UNITED STATES
NUCLEAR REGULATORY COMMISSION
WASHINGTON, D. C. 20555

The Commission has issued the enclosed Amendment No. 86 to Facility Operating License No. DPR-24 and Amendment No. 90 to Facility Operating License No. DPR-27 for the Point Beach Nuclear Plant, Unit Nos. 1 and 2, respectively. The amendments consist of changes to the Technical Specifications in response to your application transmitted by letter dated March 14, 1983 as modified by letters dated September 6, 1983 and July 13, 1984.

These amendments revise the Technical Specifications to allow the use of Westinghouse Optimized Fuel Assemblies at the Point Beach Nuclear Plant for Units 1 and 2 reloads.

ATTACHMENT TO LICENSE AMENDMENT NOS. 86 AND 90
TO FACILITY OPERATING LICENSE NOS. DPR-24 AND DPR-27
DOCKET NOS. 50-266 and 50-301

CORE DRB SAFETY LIMITS (TRANSITION CORE)
POINT BEACH UNITS 1 & 2

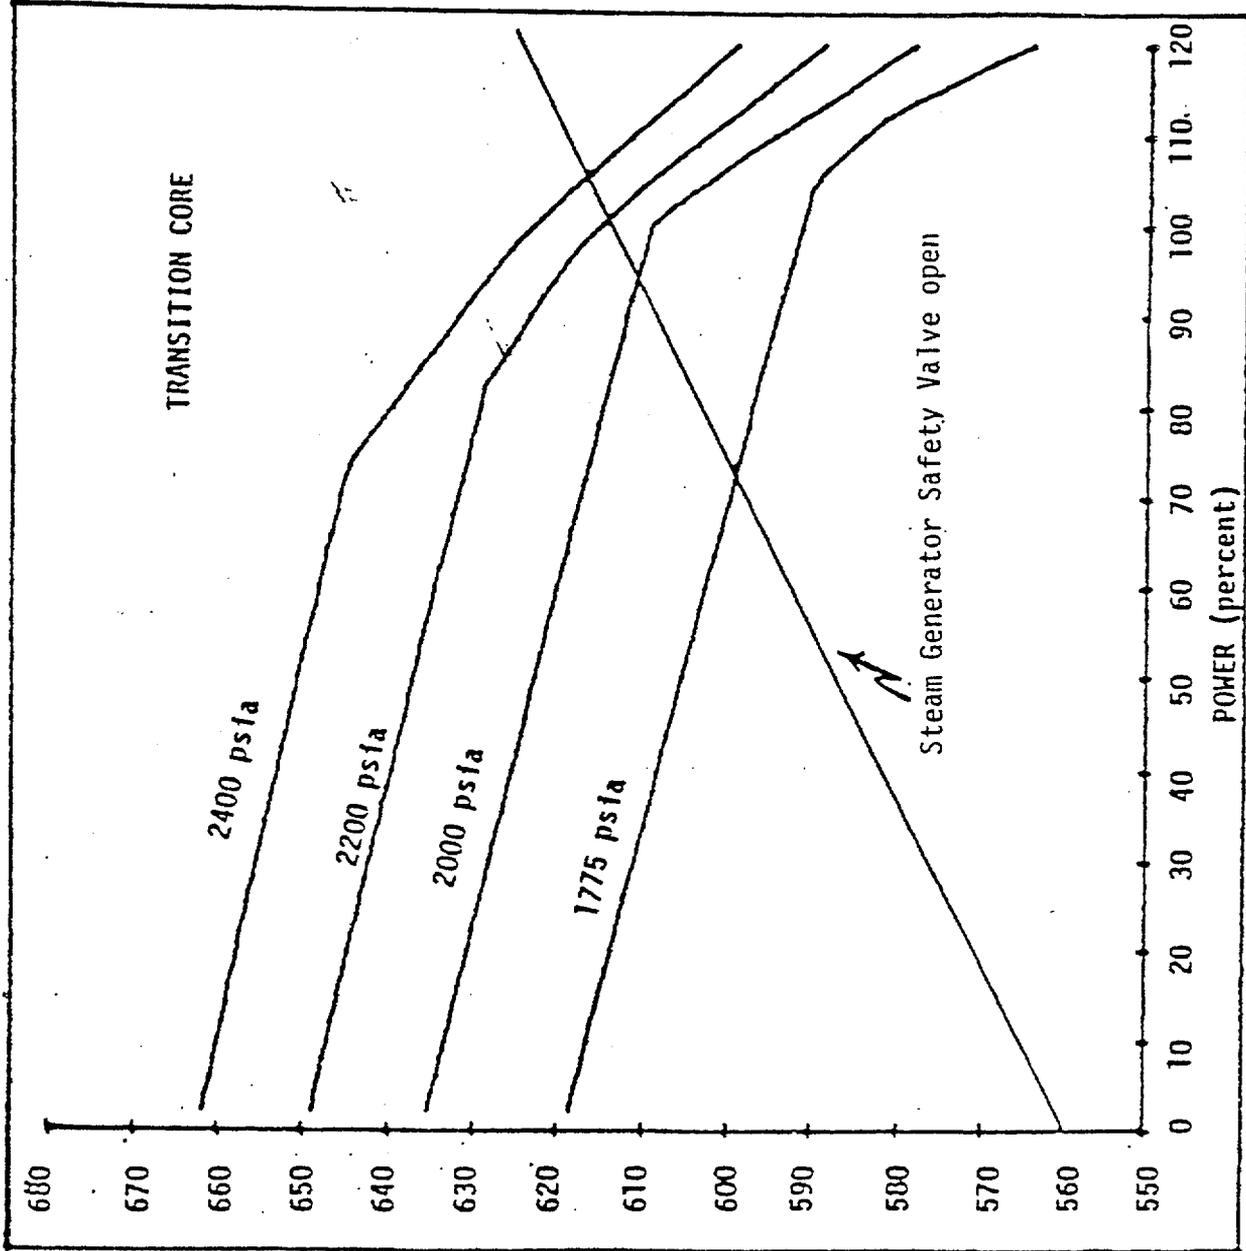
1. The combination of thermal power level, coolant pressure, and coolant temperature shall not exceed the limits shown in Figure 15.2.1-1 for a transition core* and 15.2.1-2 for the full optimized fuel assembly (OFA) core. The safety limit is exceeded if the point defined by the combination of reactor coolant system average temperature and power level is at any time above the appropriate pressure line.

The curves of Figure 15.2.1-1 are applicable to transition cores. The W-3 correlation is used to generate these curves. The DNBR limit of this correlation is shown to be met in plant safety analyses using values of input parameters with uncertainties considered at fixed conservative values.

Figure 15.2:1-2
CORE DNB SAFETY LIMITS (OPTIMIZED FUEL)
POINT BEACH UNITS 1 & 2

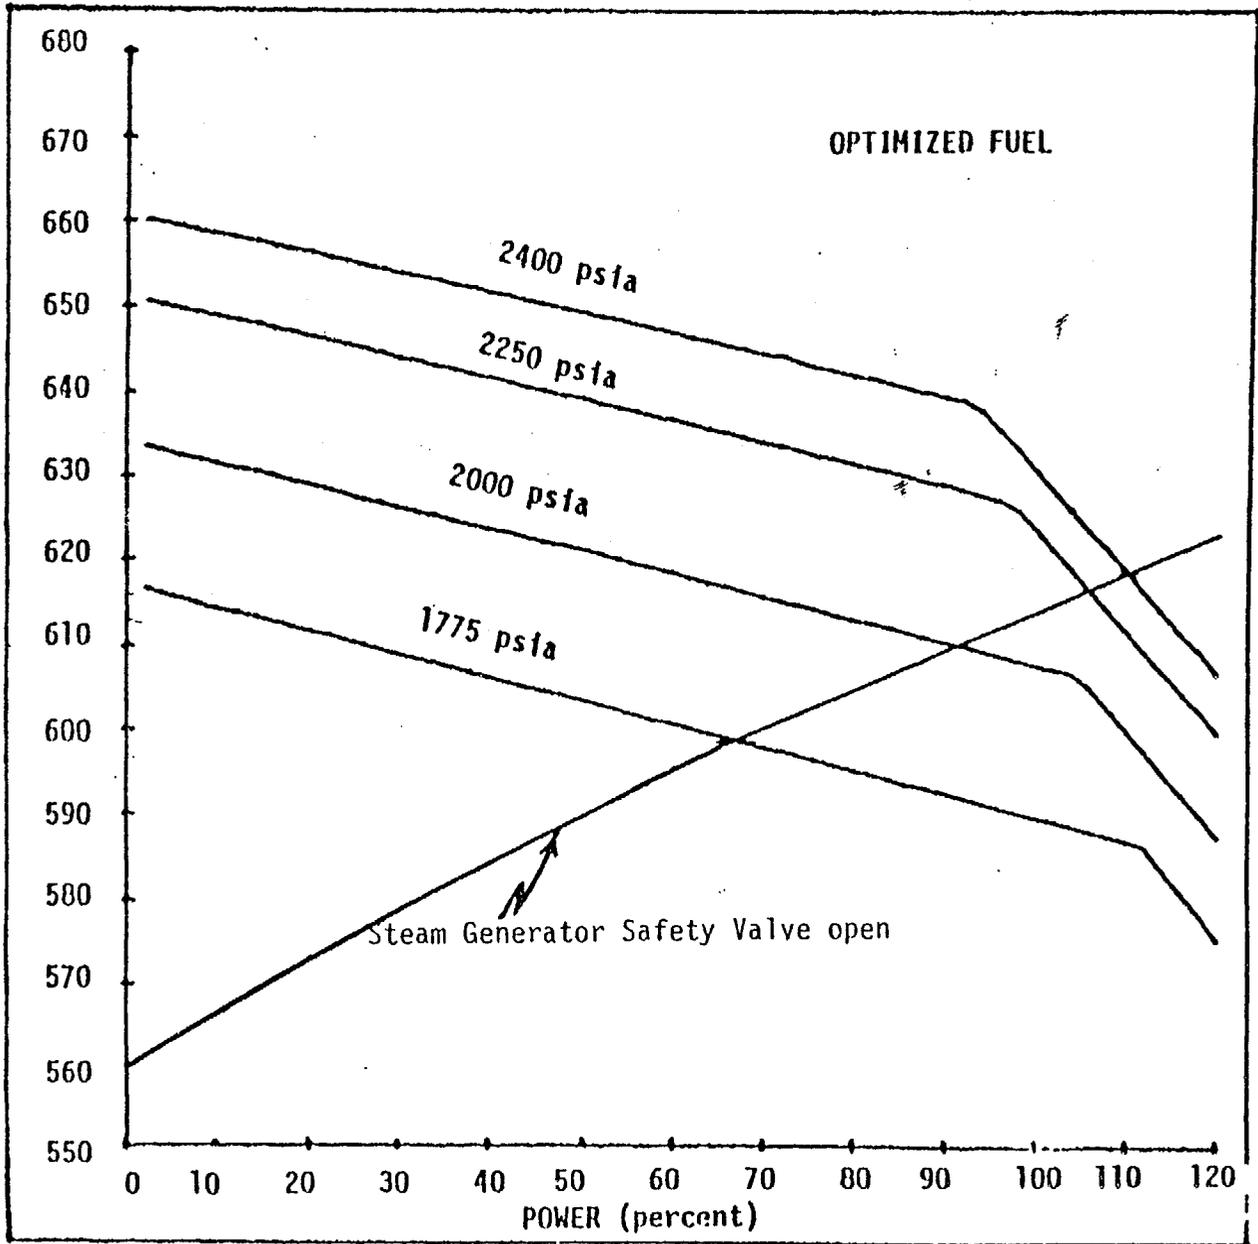
The curves of Figure 15.2.1-2 are applicable for a full core of 14x14 OFA. The WRB-1 correlation is used to generate these curves. Uncertainties in plant parameters are statistically convoluted to determine the plant DNBR uncertainty. This DNBR uncertainty, combined with the correlation DNBR limit, establishes a value of design limit DNBR. This value of design limit DNBR is shown to be met in plant safety analyses, using values of input parameters considered at their nominal values.

CONTROL BANK INSERTION LIMITS
POINT BEACH UNIT 1 AND 2

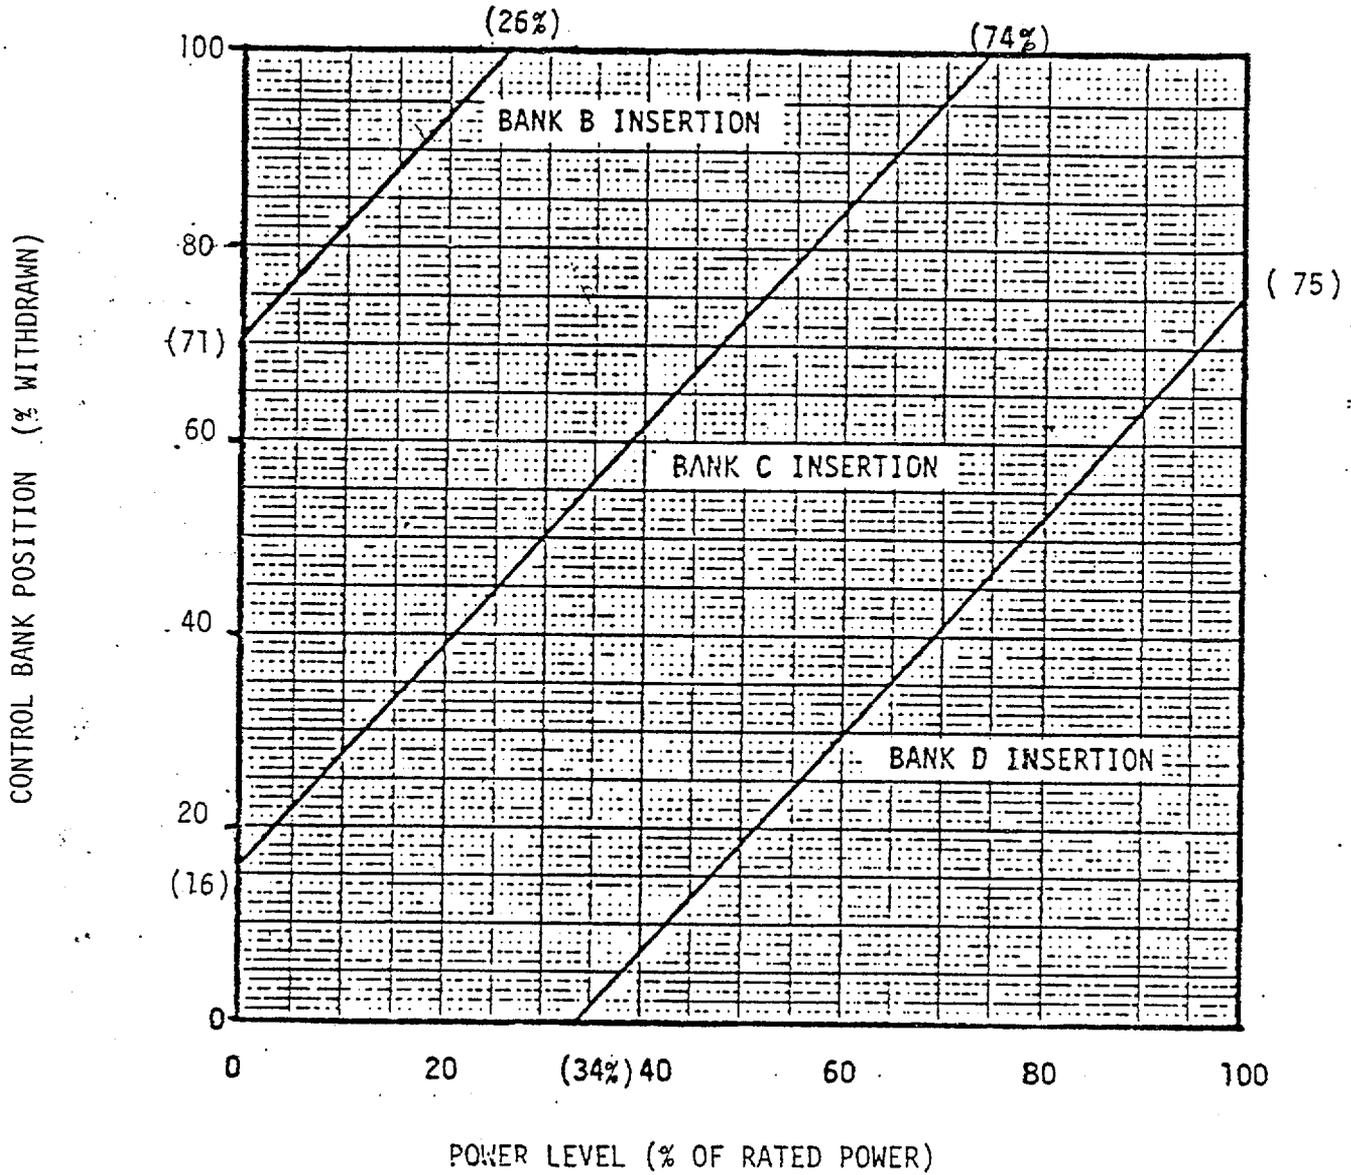
Please note that we will be transmitting the version of Figure 15.3.10-1, "Control Bank Insertion Limit Point Beach, Units 1 and 2", contained in your July 13, 1984 submittal. This revision changed the units for Control Bank Position from "steps withdrawn" to "percent withdrawn" from your earlier submittal of September 6, 1983. You are reminded that 100% fully withdrawn is still defined as 228 steps withdrawn pending the staff's completed review of your June 8, 1984 submittal. Since the Figure 15.3.10-1 contained in your July 13, 1984 submittal is the more recent and reflects use of Optimized Fuel Assemblies while the like figure in your June 8, 1984 submittal does not, no new figure 15.3.10-1 will be transmitted with the staff's completed review of that amendment request if the effective date of these amendments has passed.

FIGURE 15.3.10-3
 POINT BEACH UNITS 1 & 2
 HOT CHANNEL FACTOR NORMALIZED OPERATING ENVELOPE

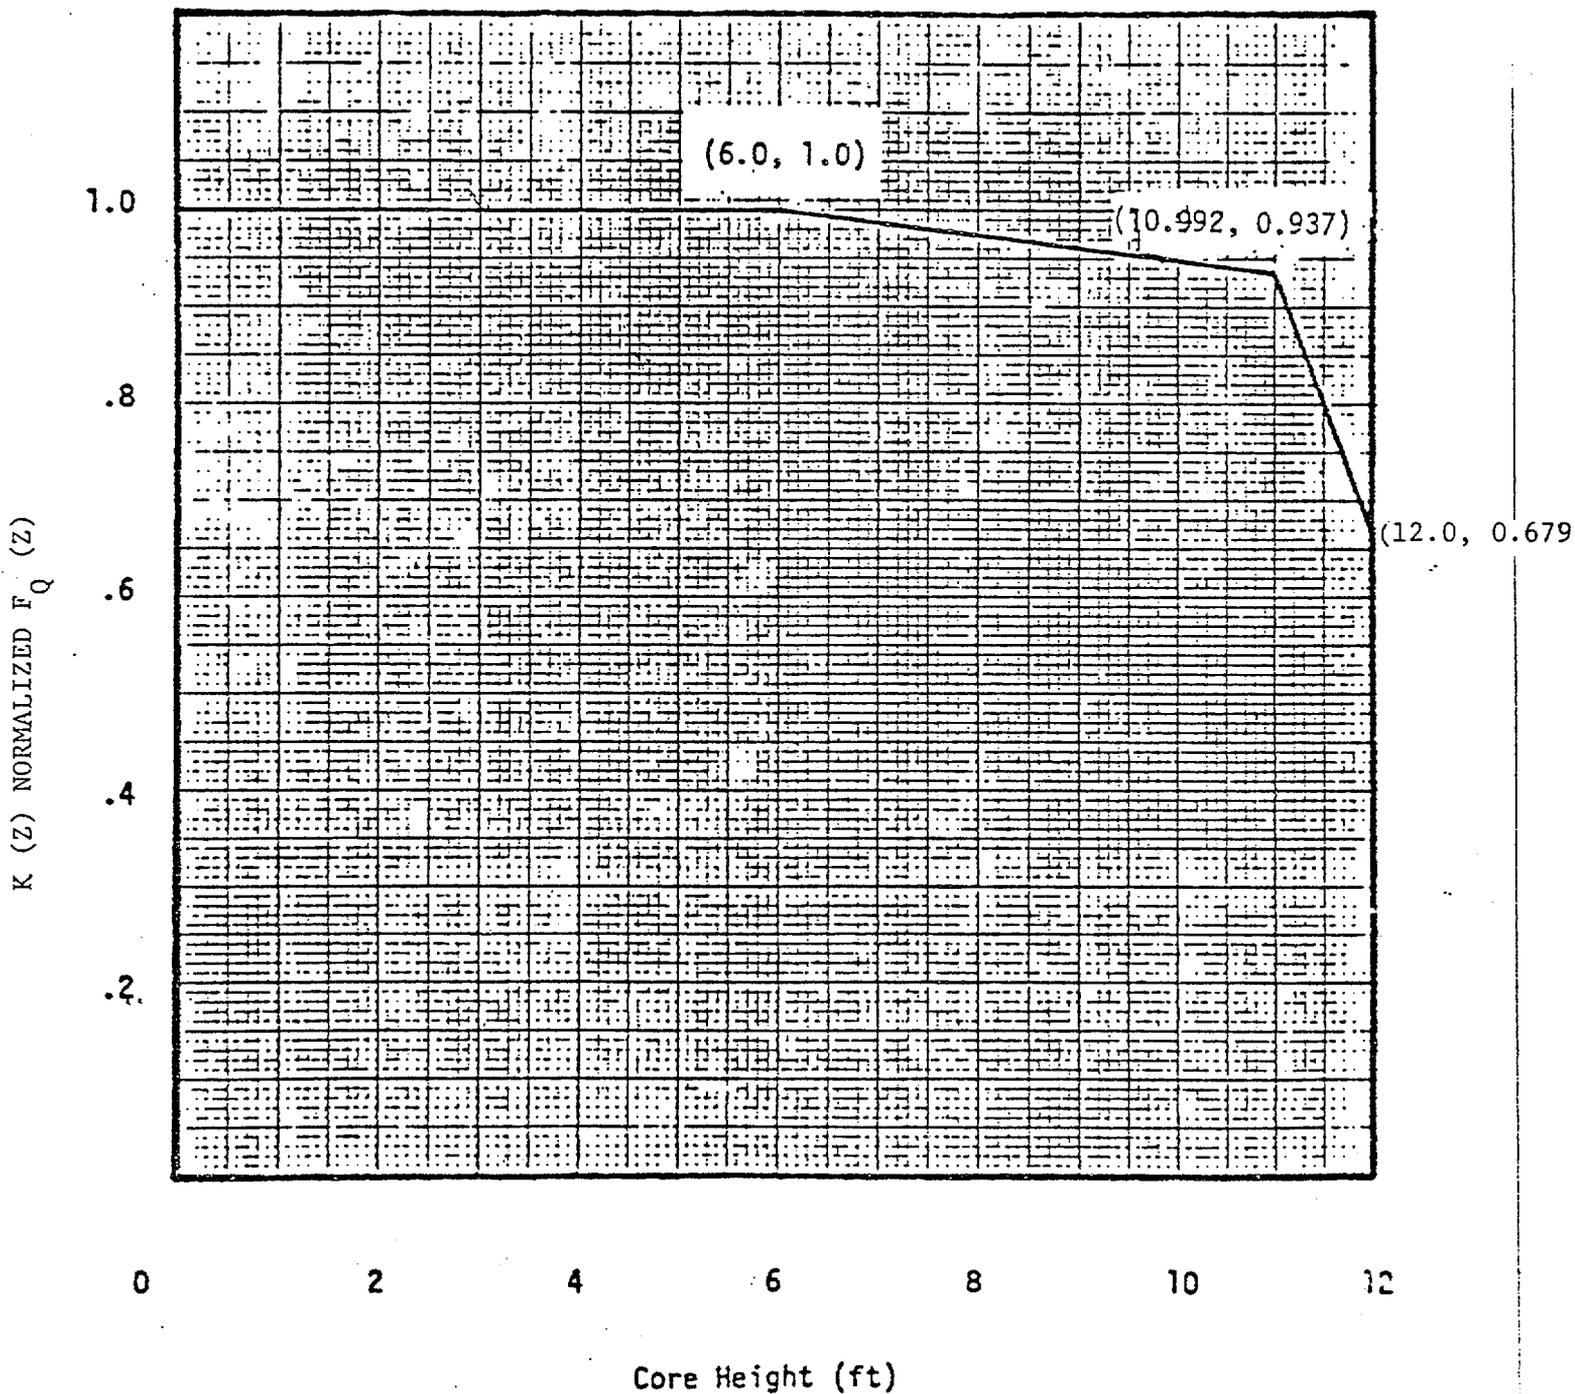
Where P is the fraction of full power at which the core is operating, K(Z) is the function in Figure 15.3.10-3 and Z is the core height location of F_Q .

An upper bound envelope of 2.21 times the normalized peaking factor axial dependence of Figure 15.3.10-3 consistent with the Technical Specifications on power distribution control as given in Section 15.3.10 was used in the LOCA analysis. The results of the analyses based on this upper bound envelope indicate a peak clad temperature of less than the 2200°F limit. When an F_Q measurement is taken, both experimental error and manufacturing tolerance must be allowed for. Five percent is the appropriate allowance for a full core map taken with the moveable incore detector flux mapping system and three percent is the appropriate allowance for manufacturing tolerance. In the design limit of $F_{\Delta H}^N$, there is eight percent allowance for uncertainties which means that normal operation of the core is expected to result in a design $F_{\Delta H}^N \leq 1.58/1.08$. The logic behind the larger uncertainty in this case is that (a) normal perturbations in the radial power shape (i.e., rod misalignment) affect $F_{\Delta H}^N$, in most cases without necessarily affecting F_Q , (b) while the operator has a direct influence on F_Q through movement of rods, and can limit it to the desired value, he has no direct control over $F_{\Delta H}^N$ and (c) an error in the predictions for radial power shape which may be detected during startup physics tests can be compensated for in F_Q by tighter axial control, but compensation for $F_{\Delta H}^N$ is less readily available. When a measurement of $F_{\Delta H}^N$ is taken, experimental error must be allowed for and four percent is the appropriate allowance for a full core map taken with the moveable incore detector flux mapping system.

FIGURE 15.3.10-4
FLUX DIFFERENCE
OPERATING ENVELOPE
POINT BEACH UNITS 1 & 2

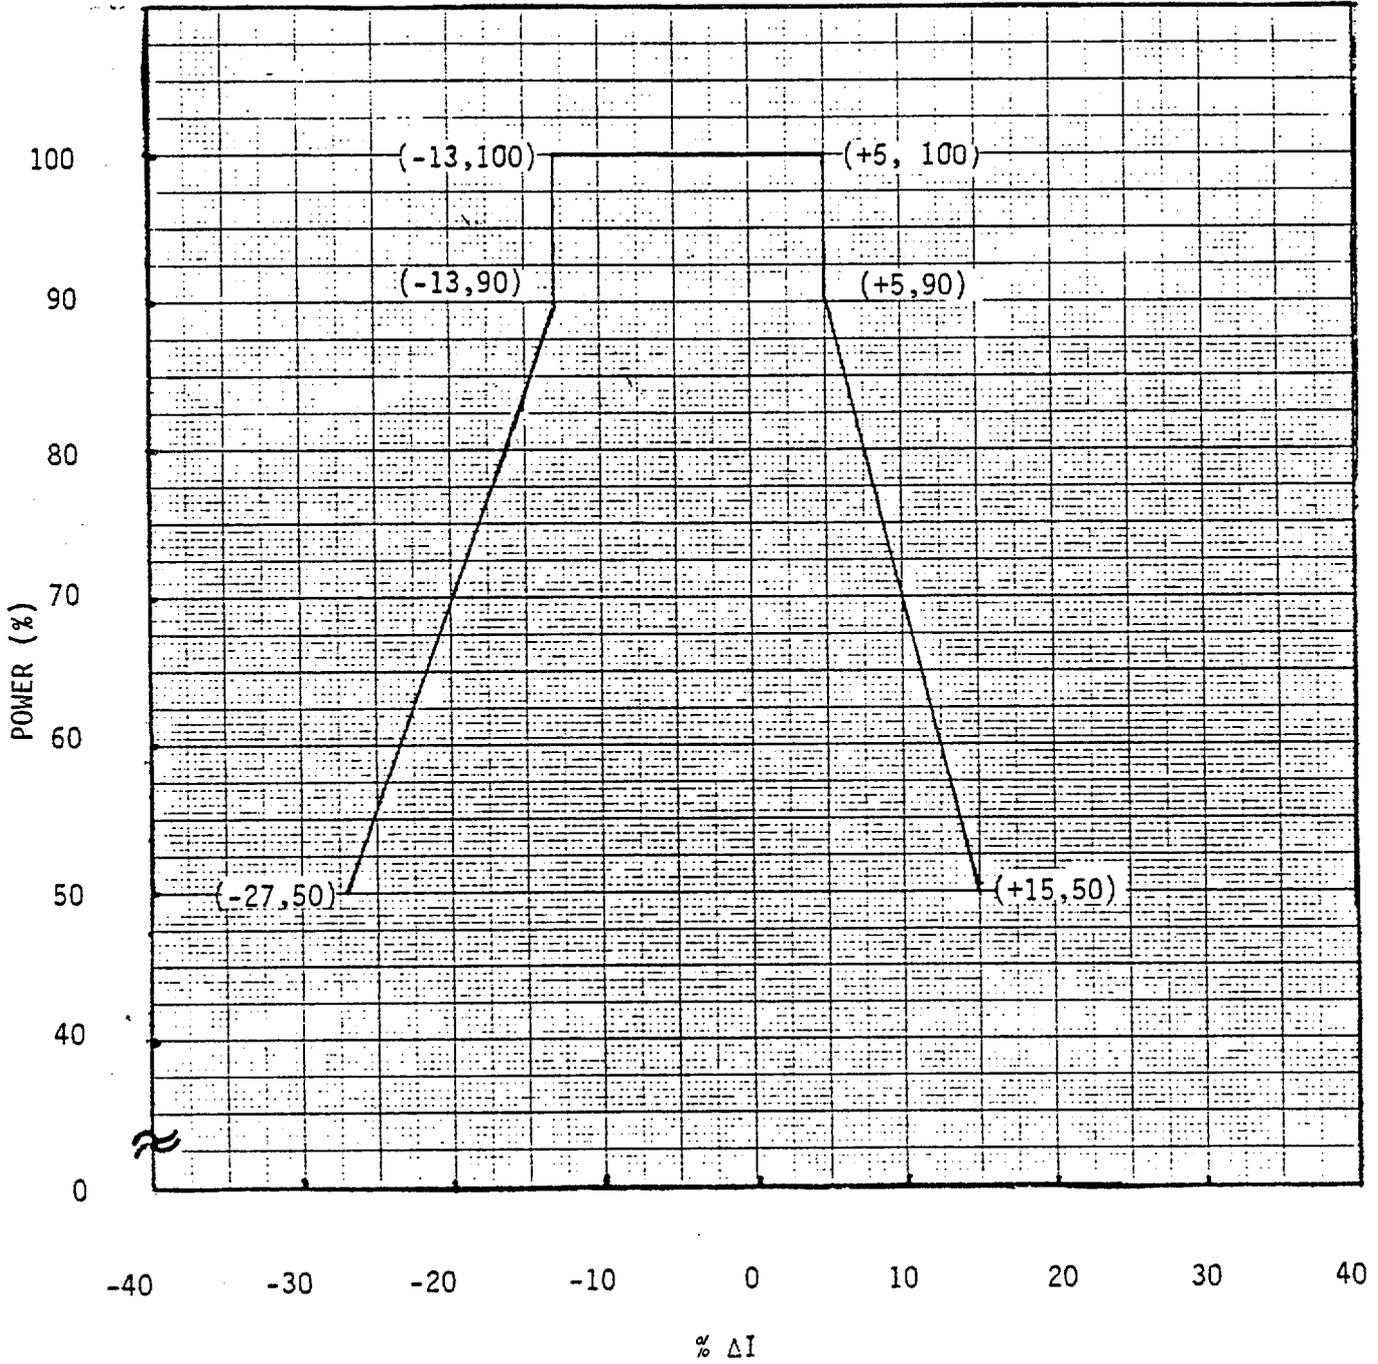
The allowable nuclear enthalpy rise hot channel factor has been increased. The allowable height dependent heat flux hot channel factor has been decreased. Axial flux difference requirements have been redefined and a new figure added to illustrate the allowable flux difference band. The time requirement for reduction of power when outside the axial flux limits have been clarified and slightly relaxed. The requirements for return to power have been relaxed to exclude the cumulative time outside the allowable band restriction. Maximum allowable rod control cluster assembly drop times have been relaxed from 1.8 seconds to 2.2 seconds. Figures illustrating control bank insertion limits and the hot channel factor normalized operating envelope have been changed to reflect previously discussed changes associated with the new fuel. Changes are also made to the section on spent fuel storage to reflect the different fuel loading of the optimized fuel assemblies as opposed to the standard fuel assemblies.

2. a. The indicated axial flux difference (AFD) shall be maintained within the allowed operational space defined by Figure 15.3.10-4 except during physics tests. The physics test exemption applies provided that the thermal power is less than or equal to 85% of Rated Power and the limits of Specification 15.3.10.B.1.a are satisfied. During suspension of the specification, the thermal power shall be determined to be less than or equal to 85% of rated thermal power at least once per hour. In addition, the surveillance requirements of 15.3.10.B.1.b shall be performed at least once per 12 hours.

- b. If the indicated AFD deviates from the Figure 15.3.10-4 limits, the AFD shall be restored to within the Figure 15.3.10-4 limits within 15 minutes. If this cannot be accomplished, then reactor power shall be reduced until the AFD is within the envelope or the power level is less than 50% of Rated Power. Normally the rate of power reduction is 15% per hour. Once AFD has been returned to and maintained within the operating envelope, power level is no longer restricted. If it is necessary to reduce power to 50%, the Power Range Neutron Flux-High Trip Setpoints shall be reduced to less than or equal to 55 percent within the next 4 hours.
